HISTORIC PRESERVATION BOARD STAFF REPORT

160 Marine Way

Meeting	File No.	Application Type
August 5, 2026	HP-417-2026	Certificate of Appropriateness & Waiver

The item before the Board for consideration of a Certificate of Appropriateness (HP-417-2026) and Waiver in association with exterior modifications to an existing contributing structure and a 3rd story addition to the existing, contributing, single-family residence, located at **160 Marine Way, Marina Historic District**.

PROPOSED SECOND FLOOR DEMOLITION PLAN

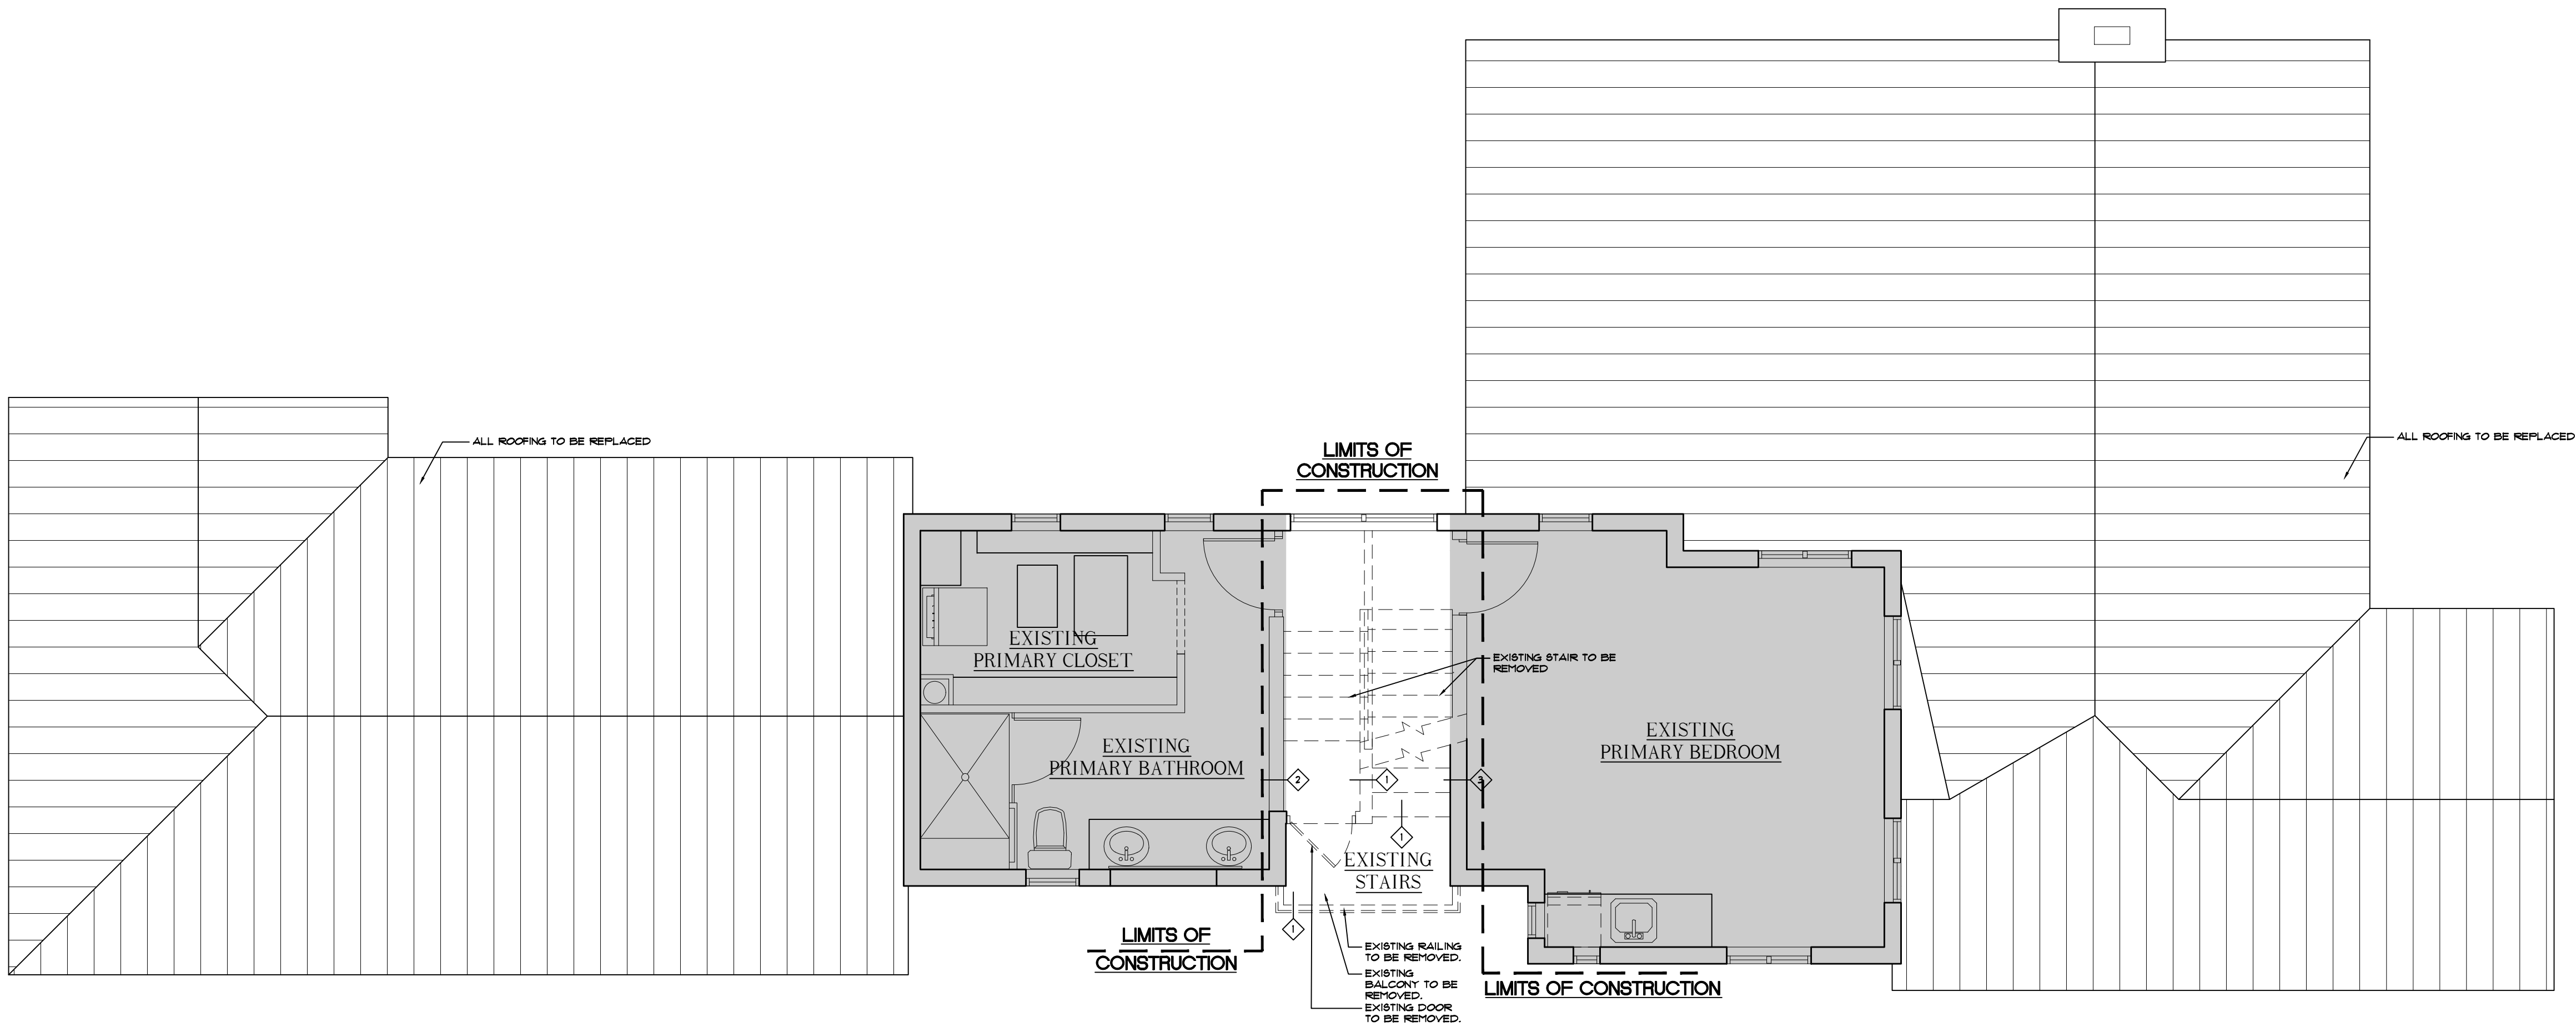
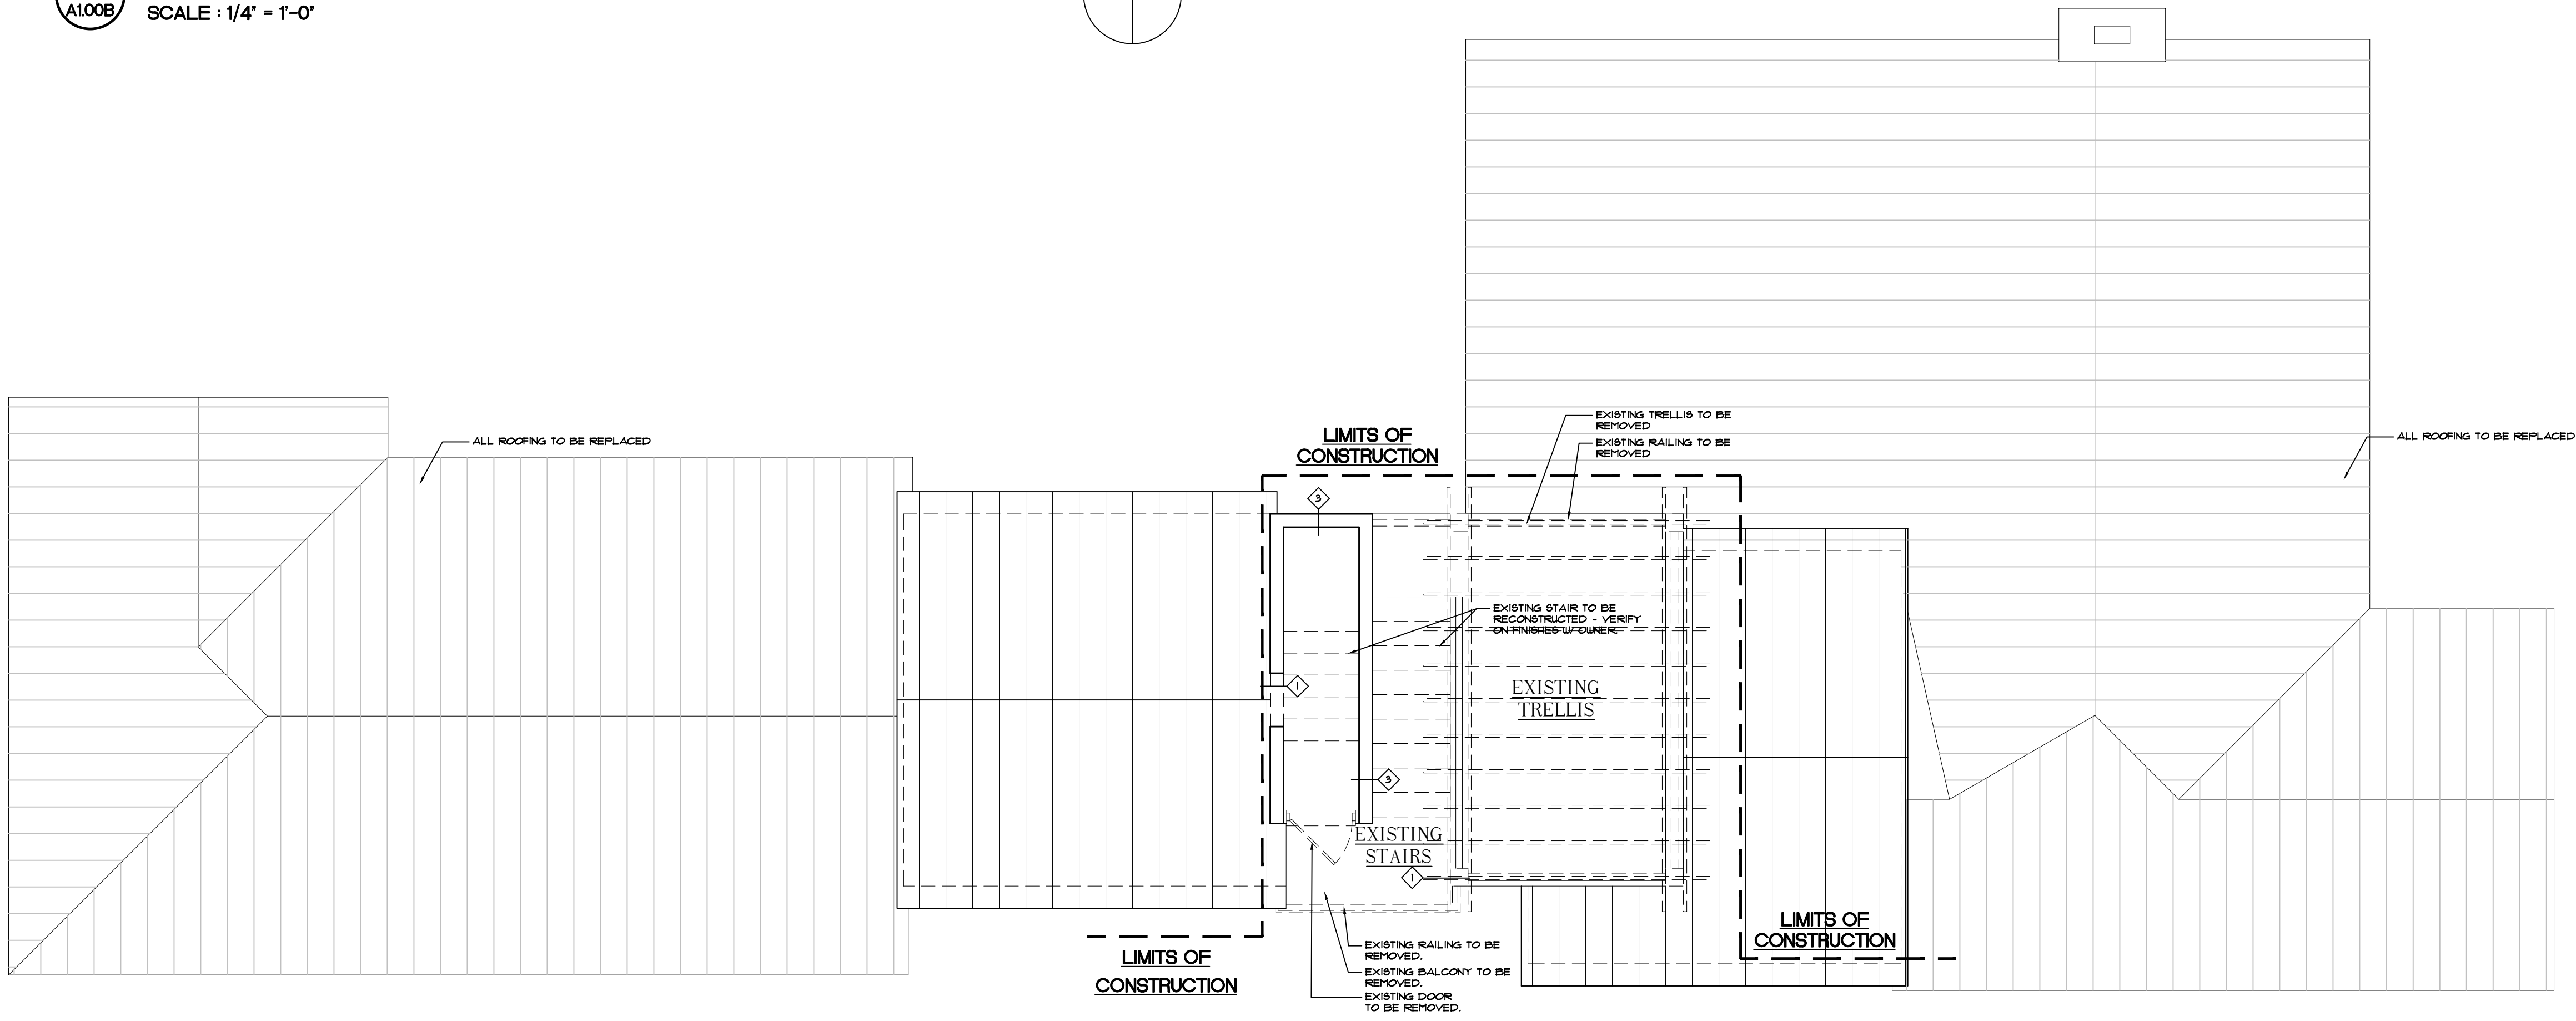
The applicant has submitted plans for the demolition of the existing stairway and balcony on the second-floor and third-floor rooftop trellis. Since the proposed area of demolition is located on a non-contributing portion of the structure (the two-story portion of the residence that was built in 1994) and with the total square footage of area to be demolished at 21% the requirements of this section of the code are not applicable to the request.
